Environmental Services - Water Quality
Onsite Wastewater Scan Data Entry Form

PERMIT #: D015560 PIN #: 1811275606

Lot 2, Bent Place D-15560

TAP CHART Lot 2 Bent Place, REVISED 2-14-01 KHM

CA Site Plan D-15560 Revised 2-14-01 ETof.

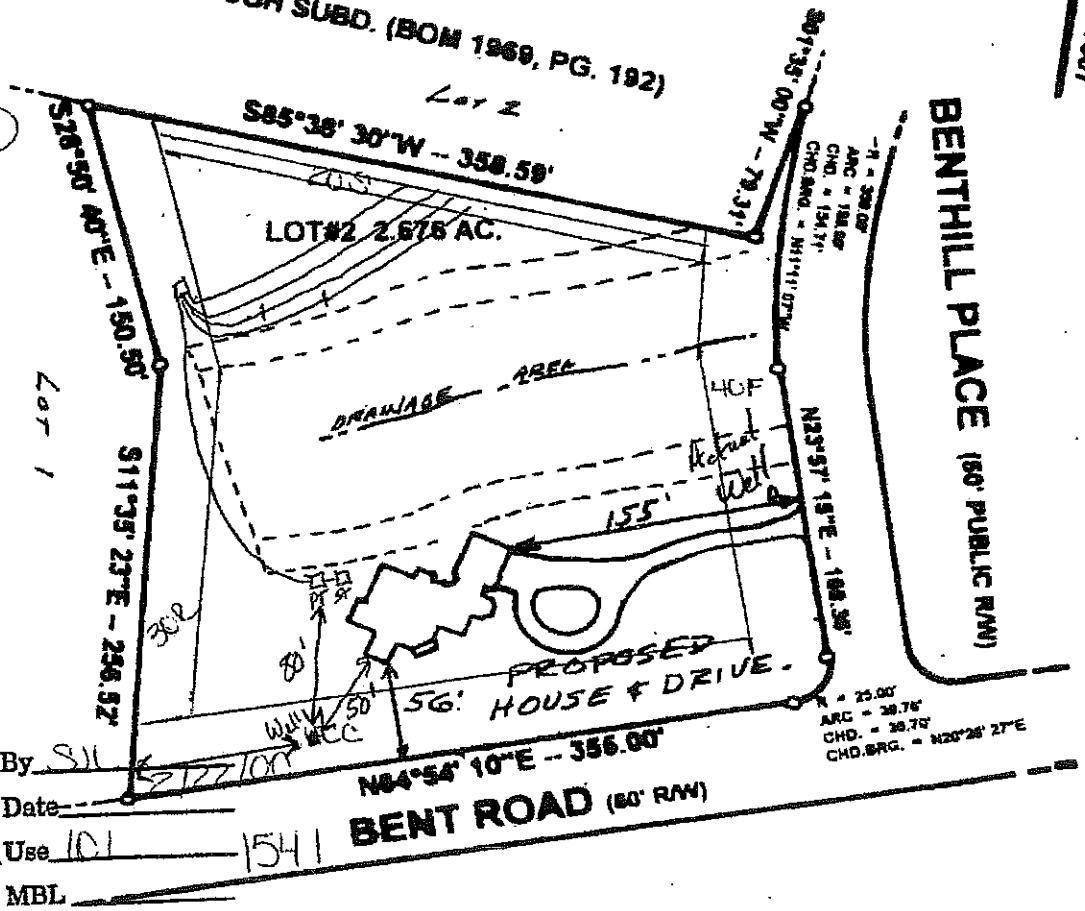
Contractors shall install system on contours, see attached site plan for wastewater system design and well location. No underground utilities, water lines or sprinkler systems may be located in the original system or repair areas. A septic tank filter with a riser for access is required. The wastewater system shall not be covered or placed into use until inspected by the Wake County Department of Environmental Services and an Operation Permit issued. **OTHER CONDITIONS:**
SEPTIC TANK FILTER/RISER FOR ACCESS REQUIRED. SYSTEM REQUIRES USE OF PRESSURE MANIFOLD DESIGNED BY FEBRUARY ASSOC., INC.. THE DESIGN REQUIRES THE USE OF AN INNOVATIVE DRAINFIELD PRODUCT WITH THE 25% REDUCTION ALREADY CALCULATED INTO THE DESIGN. THE PLANS FOR THE CONSTRUCTION OF THE MANIFOLD MUST BE FOLLOWED CLOSELY. A SIMPLEX CONTROL PANEL WITH ELAPSED TIME METER, CYCLE COUNTER AND ALARM AND PUMP WIRED ON SEPARATE CIRCUITS IS REQUIRED. THE SUPPLY LINE MUST BE LOCATED OUTSIDE OF THE DEDICATED DRAINAGE AREA. MANIFOLD PLANS REVISED ON 2-14-01 TO SIMPLYFY CONSTRUCTION. 2" SUPPLY LINE NOW BEING USED WITH A LARGER PUMP. SEE REVISED TAP CHART WITH APPROVAL STAMP FOR DETAILS OF CHANGE.
